# Access Compliance Report

## Public Rights-of-Way

Intersection ID: 49309	Main Street: NATIONS_FORD_RD	Cross Street: PANGLE_DR	Location: E
ADA ID: 6992FDB5ED3C	Ramp Type: PerpDiag	Initial Pass/Fail: Fail	Overall Compliance: No
			Severity Score: 13.75

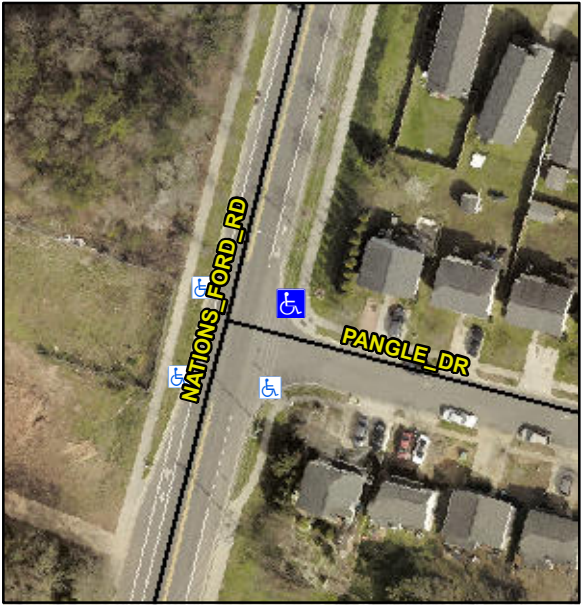
Codes/Mitigation Info/Possible Solution			Field Measurements/Component Compliance		
	Possible Solutions:		<b>Compliance</b>	<b>Description</b>	<b>Data</b>
	<b>Remove &amp; Replace Curb Ramp With Two New Directional Ramps or Equivalent.</b>		<b>No</b>	Ramp Length (in)	<b>52.0</b>
			<b>Yes</b>	Ramp Width (in)	<b>48.0</b>
			<b>N/A</b>	Flare Type LT	<b>N/A</b>
			<b>N/A</b>	Flare Slope LT (%)	<b>N/A</b>
			<b>N/A</b>	Flare Traversable LT?	<b>N/A</b>
			<b>N/A</b>	Landing Length (in)	<b>N/A</b>
			<b>N/A</b>	Landing Width (in)	<b>N/A</b>
			<b>N/A</b>	Landing Slope (%)	<b>N/A</b>
			<b>N/A</b>	Landing X Slope (%)	<b>N/A</b>
<p>Surveyor Notes:</p> <p><b>N/A</b></p> <p>PROW/ADA:</p> <p><b>Not Found, R304.2.2, R304.5.3</b></p>			<b>N/A</b>	Flare Type RT	<b>N/A</b>
			<b>N/A</b>	Flare Slope RT (%)	<b>N/A</b>
			<b>N/A</b>	Flare Traversable RT?	<b>N/A</b>
			<b>N/A</b>	DWS Provided?	<b>N/A</b>
			<b>N/A</b>	DWS Contrast?	<b>N/A</b>

<b>N/A</b>	DWS Length (in)	<b>N/A</b>
			<b>N/A</b>	DWS Full Width?	<b>N/A</b>
			<b>N/A</b>	DWS Offset (in)	<b>N/A</b>
			<b>N/A</b>	Gutter Ponding?	<b>N/A</b>
			<b>N/A</b>	Gutter Lip Ht (in)	<b>N/A</b>
			<b>No</b>	Painted X Walk1?	<b>No</b>
				X Walk 1 Direction	<b>To NW</b>
			<b>N/A</b>	X Walk 1 Width (in)	<b>N/A</b>
			<b>5.2</b>	X Walk 1 Slope (%)	<b>1.6</b>
			<b>0.6</b>	X Walk 1 X Slope (%)	<b>5.9</b>
			<b>N/A</b>	Ramp inside XWalk1?	<b>N/A</b>
			<b>5.8</b>	Road Slope (%)	<b>N/A</b>
			<b>3.9</b>	Road X Slope (%)	<b>N/A</b>
			<b>N/A</b>	Any Obstructions?	<b>N/A</b>
				Obstruction Type	
Total Cost: \$ 3200.00			<b>N/A</b>	Storm Grate/Utility Hazard?	<b>N/A</b>
			<b>N/A</b>	Storm Grate/Utility Type	<b>N/A</b>
			<b>Yes</b>	Surface Condition? (G/P)	<b>Good</b>
